PROPOSED CHANGES

APPLICATION REPORT

Appendix 5 – Flood Risk

Drax Bioenergy with Carbon Capture and Storage

Plate 7.3 - Demolished Buildings Footprints

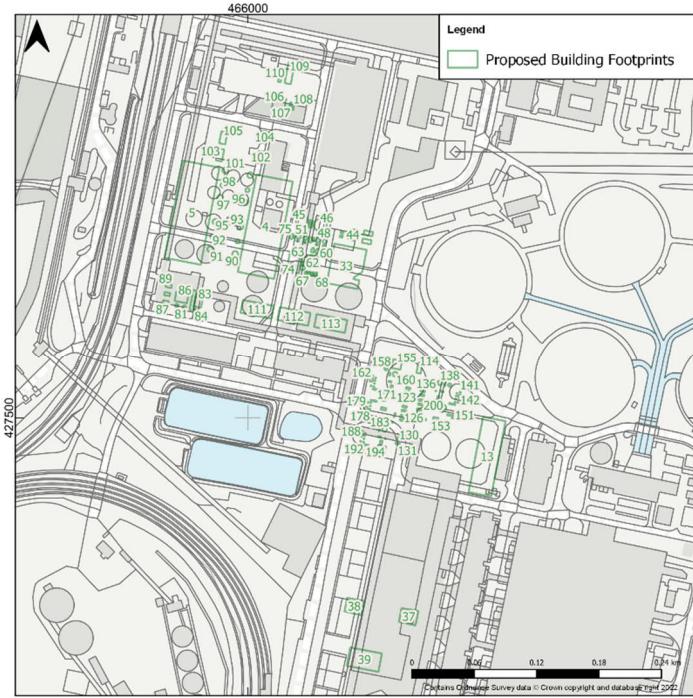
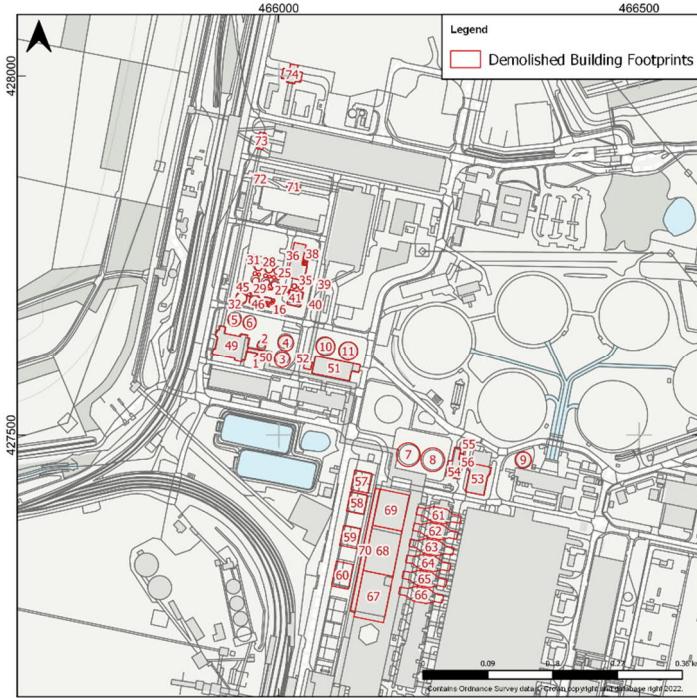
7.1.12. Notwithstanding this demolition, the comparison of the built footprint in the design event floodplain (including climate change allowances) ~~is detailed in Table 7.2 has been undertaken in GIS to determine the magnitude of the floodplain compensation required included for the design event:~~

- g. The findings of the GIS assessment demonstrate that the proposed footprint is larger than the footprint of buildings which will be demolished to facilitate the Proposed Scheme (Table 7.2).

- 7.1.13. The footprints which are to be demolished are shown in Plate 7.3 and the proposed footprint areas are shown in Plate 7.4, these are extracted from the 3D ground model (APP-198) also provided in more detail in Appendix M, where they are overlaid with the flood extents.

<u>Design Scenario (FT2) Areas Flooded (m²)</u>
<u>Demolished</u>	<u>5051.9</u>
<u>Proposed</u>	<u>8443.8</u>
<u>Change in built footprint</u>	<u>+3391.9</u>
